HALL OF FAME CAR WASH AT WALLBROOK (LOT 8)

Town of Rolesville Project Numbers: SDP 25-01 / CID 24-03

V1

#	DATE	DESCRIPTION
1	2-JAN-25	INITIAL SUBMITTAL FOR REVIEW

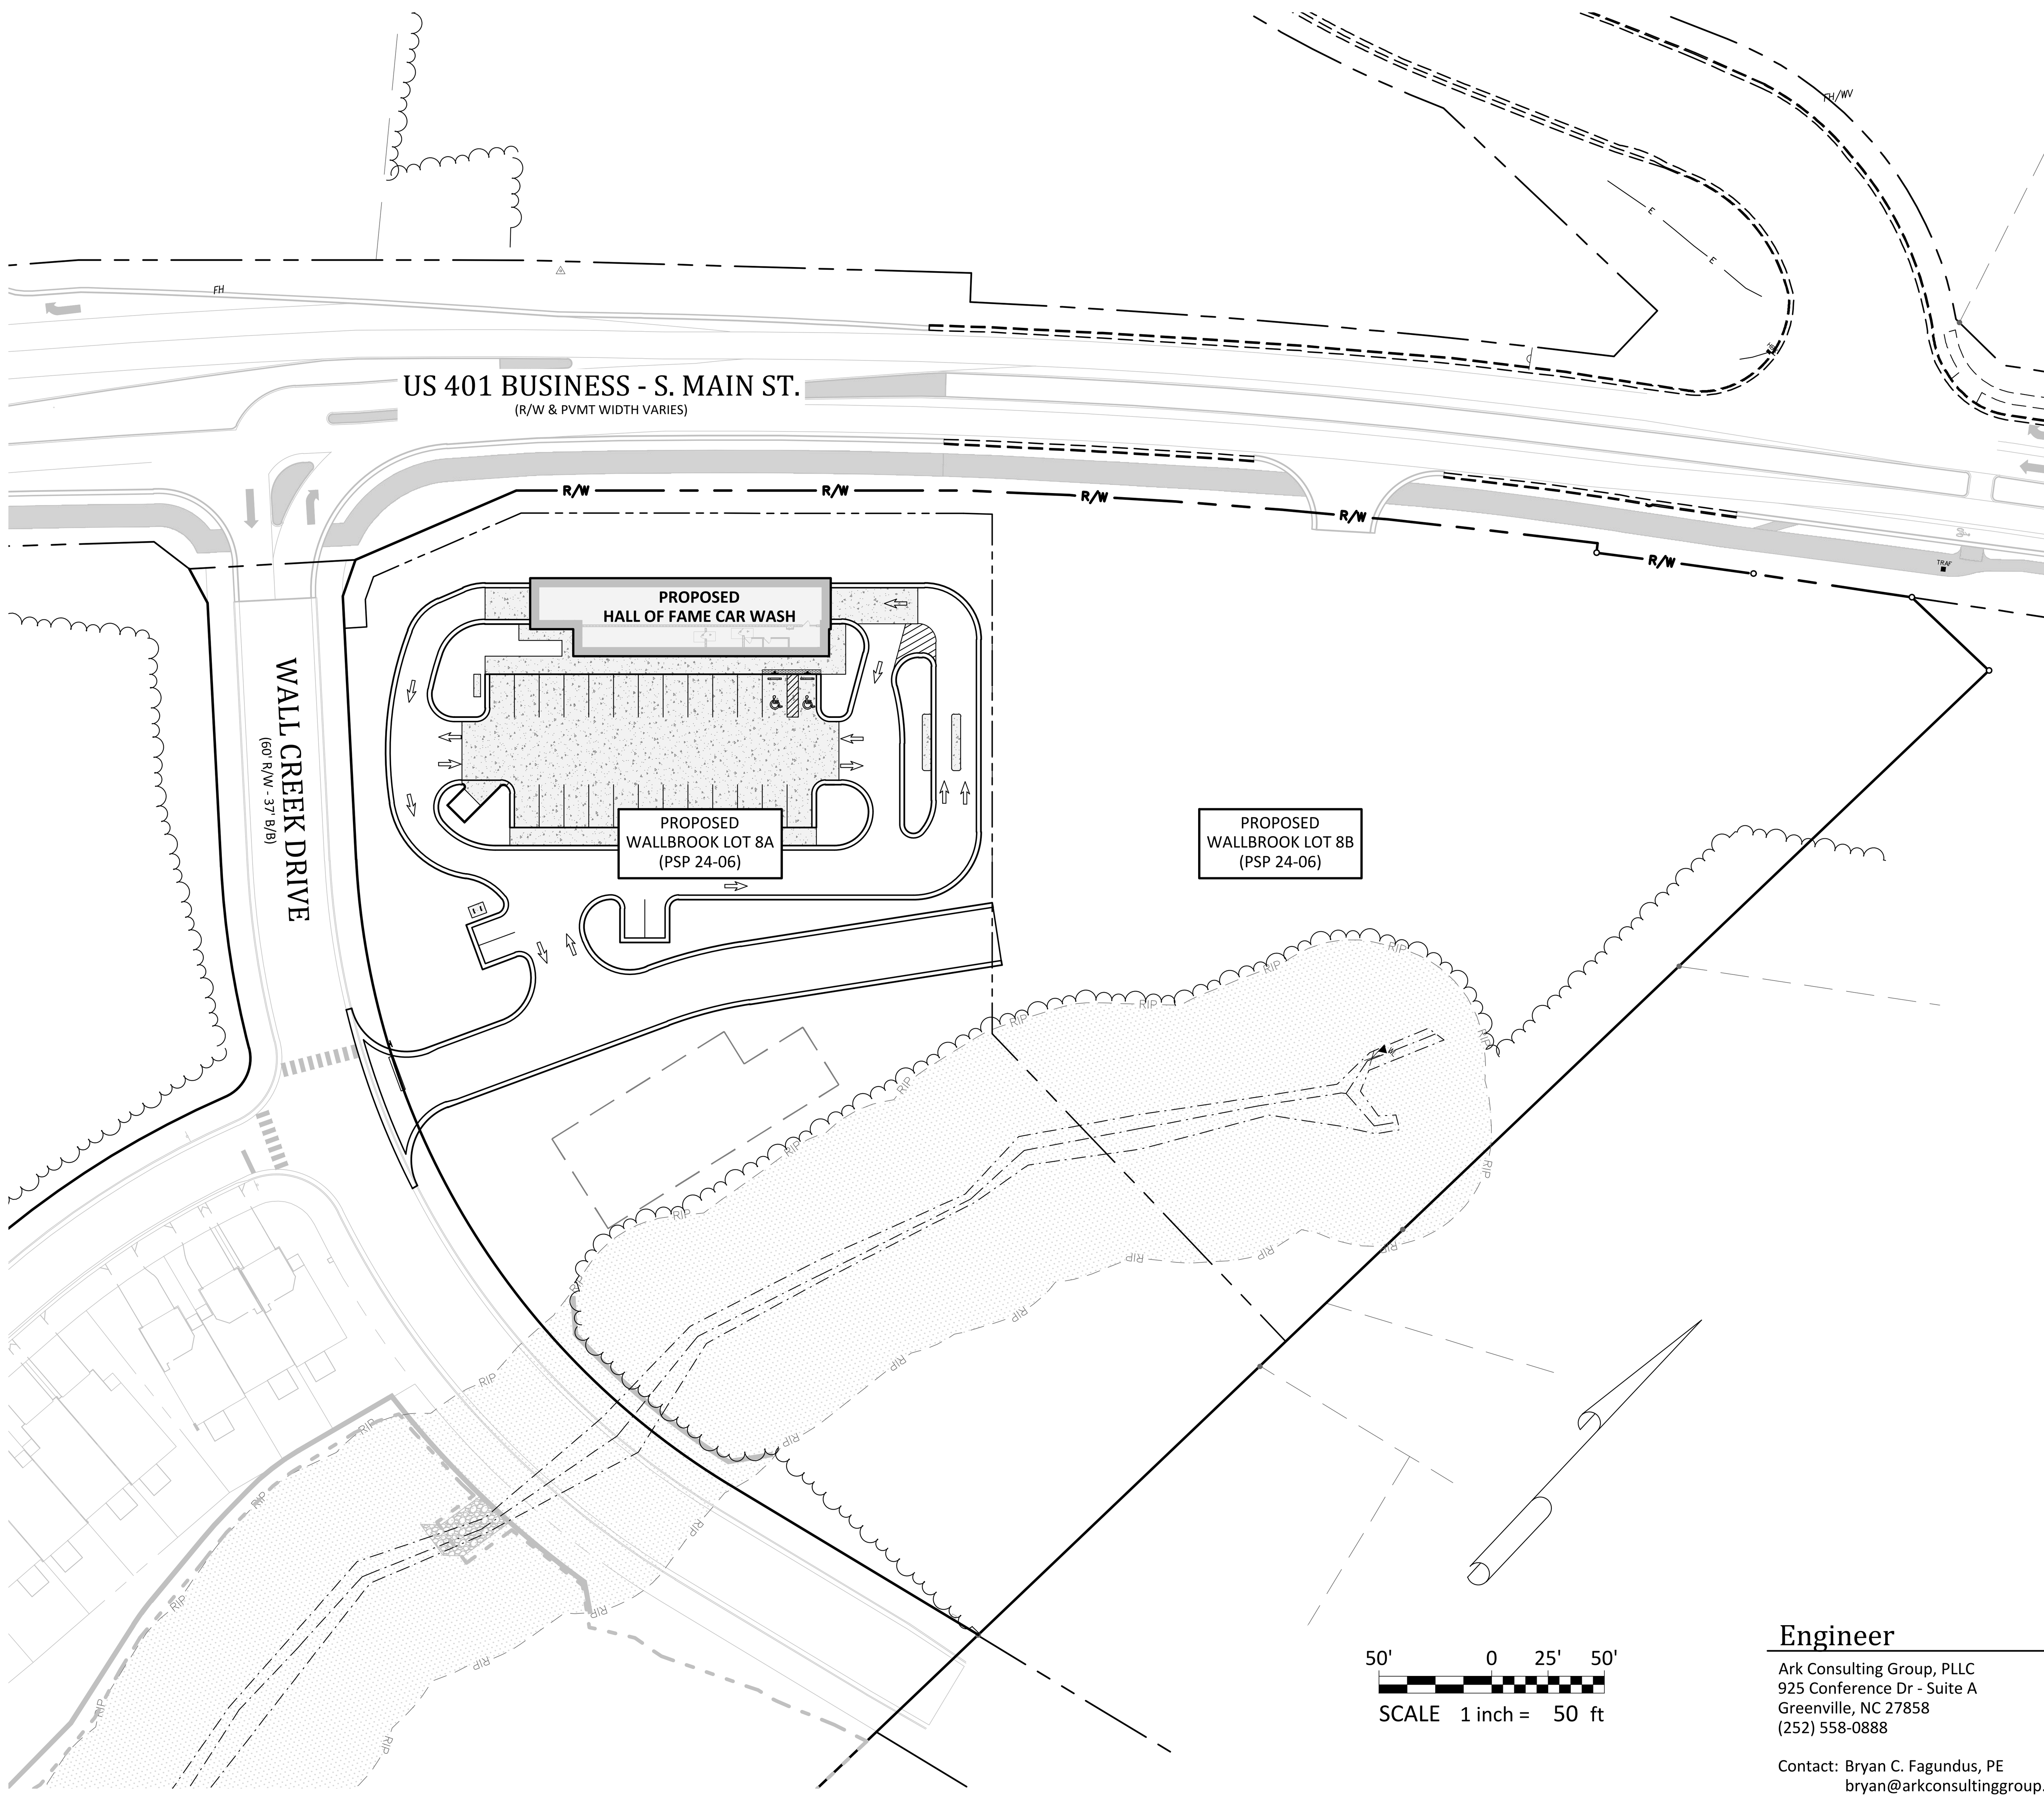
4. **Holding Comment** – This lot must be recorded (Final subdivision plat, FSP) prior to SDP/CID approval.

Wake Co Fire / EMS - Brittany Lingle/Stephen Wolf	**Provide diagram indicating firetruck can navigate parking lot- 50 ft truck length

SITE PLAN

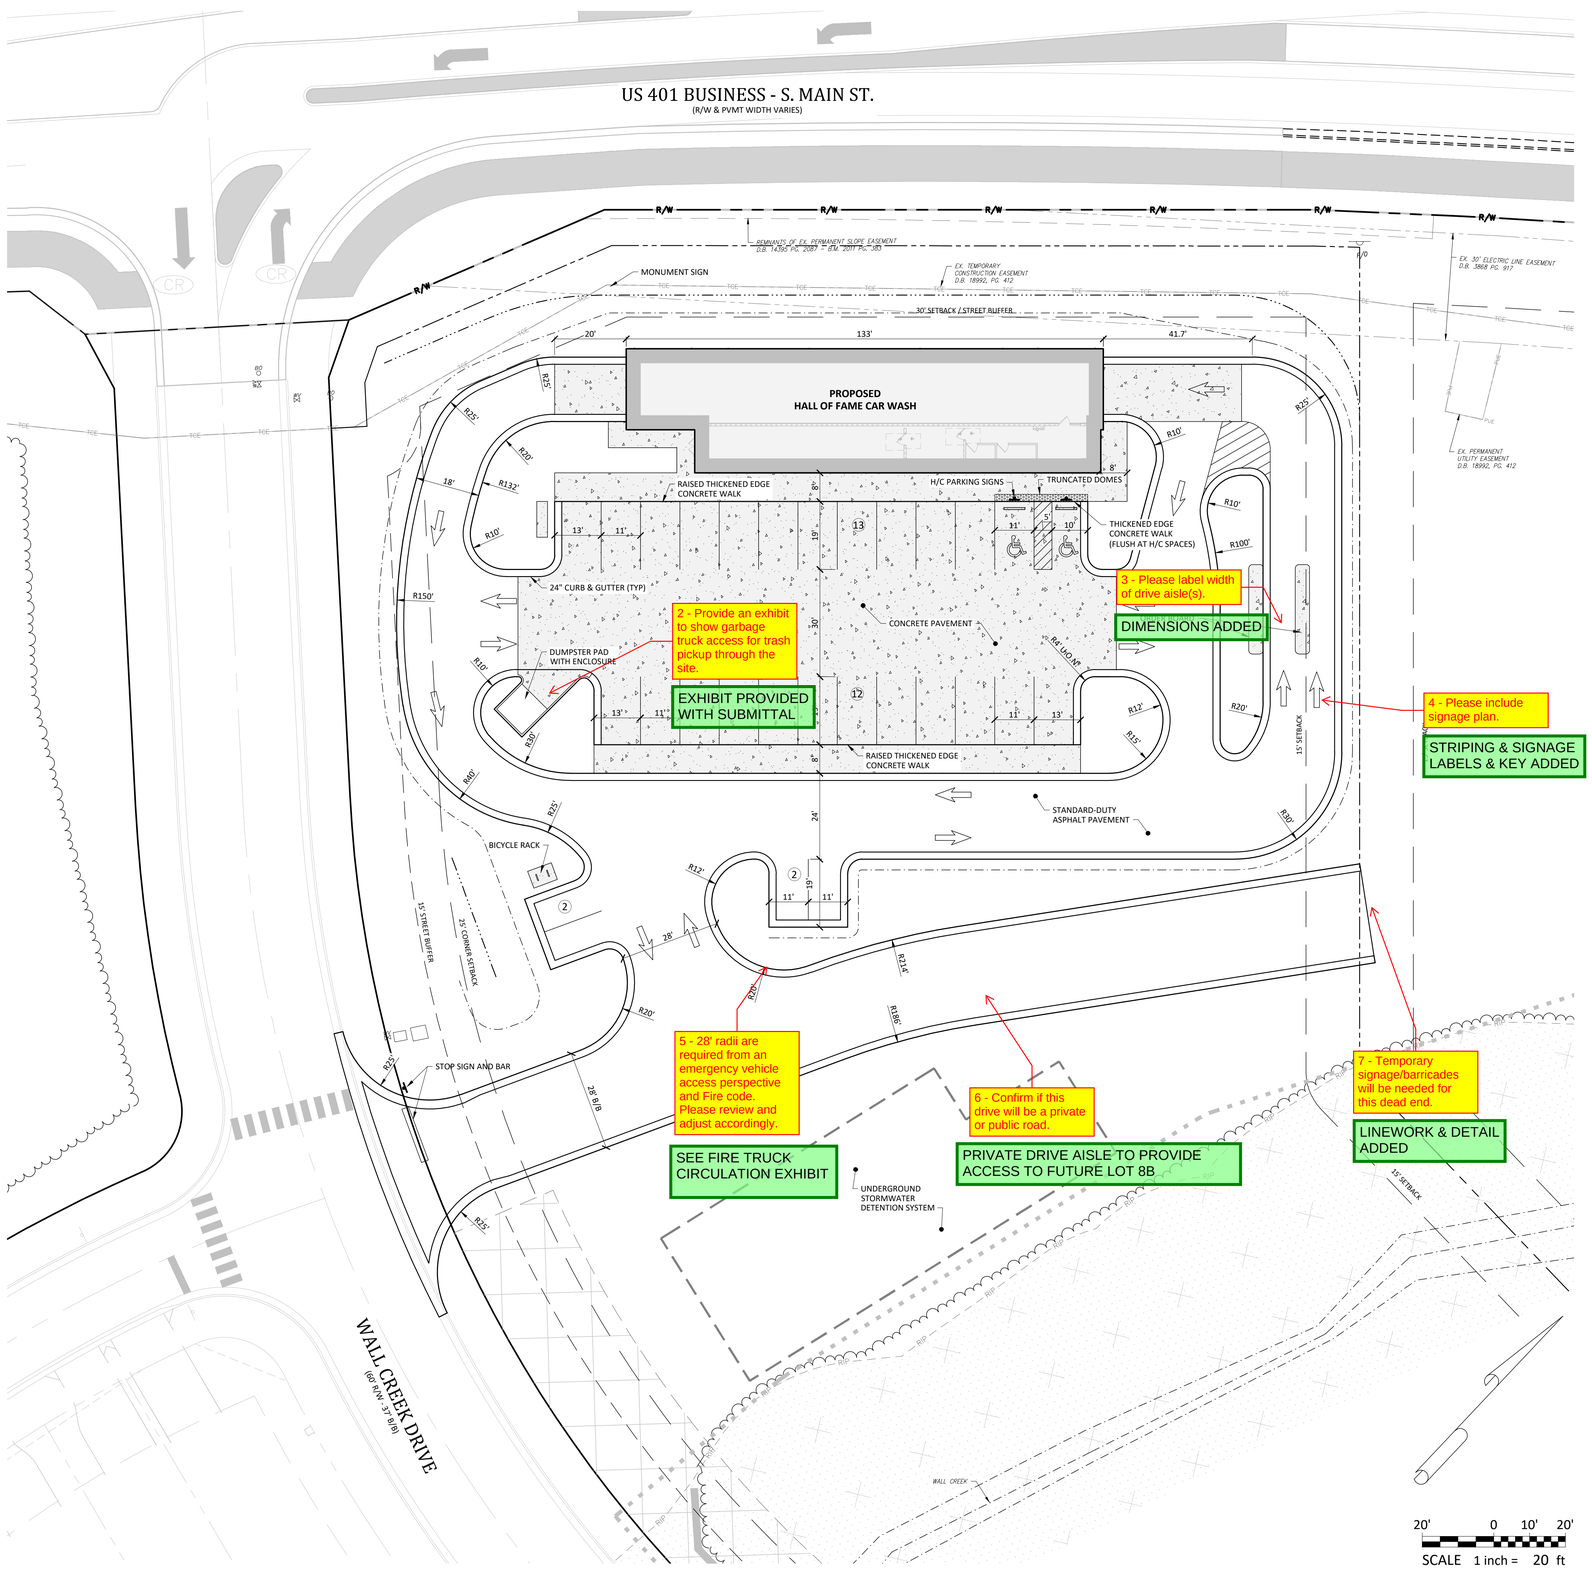
5. **Non-Residential Open Space** - Demonstrate that the open space requirement of a non-residential development has been met per LDO Section 6.2.1.D.3. Provide reference to the LDO Section 6.8.4.B.2 of pedestrian amenities being provided (min. 4). Replicate Compliance demonstration as the parking requirements breakdown on sheet C0.1.

6. **Trash Enclosure Screening/Sheet C5.0** – Provide demonstration of compliance with LDO 6.2.4.6.B. screening requirements; provide 'typical' enclosure drawings.

OPEN SPACE MET AS PART OF OVERALL WALLBROOK DEVELOPMENT
REFER TO SCREENSHOT BELOW OF APPROVED PR 21-04 REVISED

PEDESTRIAN AMENITIES ADDED CALLED OUT ON SITE PLAN AND TABLE ON COVER AS REQUESTED

UTILITY PLAN

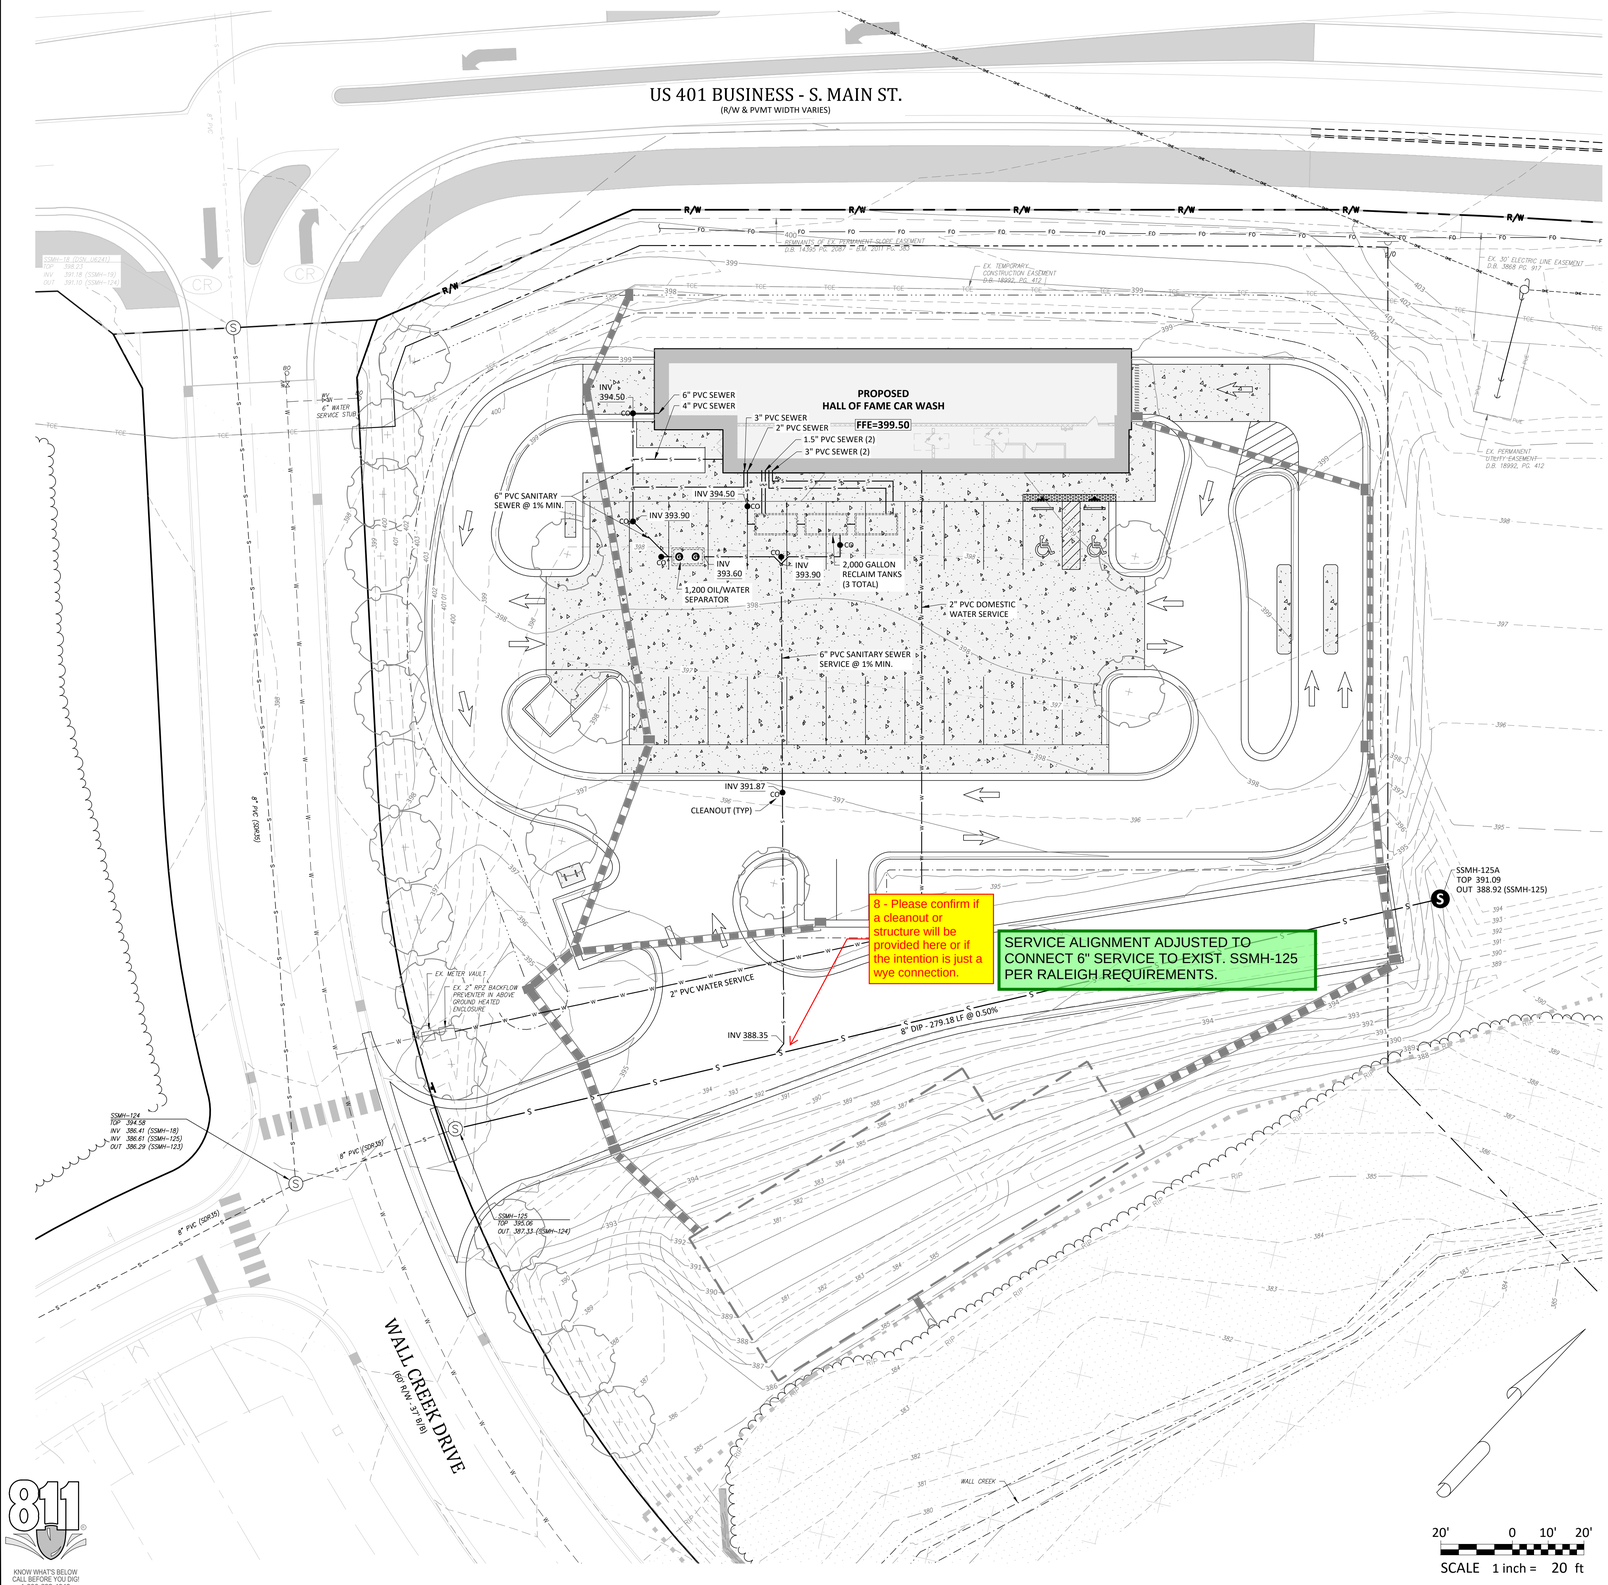
8 - Please confirm if a cleanout or structure will be provided here or if the intention is just a wye connection.

COR Public Utilities - Tim Beasley	1. When will the public sewer extension be permitted that was shown on the PSP? If the intention is to permit the extension with this SDP, show Proposed Easement around the SS extension, provide plan/profile sheets, add/include the public Sewer permit block on the applicable sheets. 2. Are the meter vault and BFP existing or are they being constructed/installed with this SDP? What size is the water meter? Please provide size, make and model # for the BFP. 3. Please show City of Raleigh Waterline Easement extended from the R/W, 1' on each side of the meter vault. 4. The 6" sanitary sewer service must connect to the sanitary sewer main at a manhole. 5. Email for the public improvements quantities table that will need to be included on the Cover.

SERVICE ALIGNMENT ADJUSTED TO CONNECT 6" SERVICE TO EXIST. SSMH-125 PER RALEIGH REQUIREMENTS.
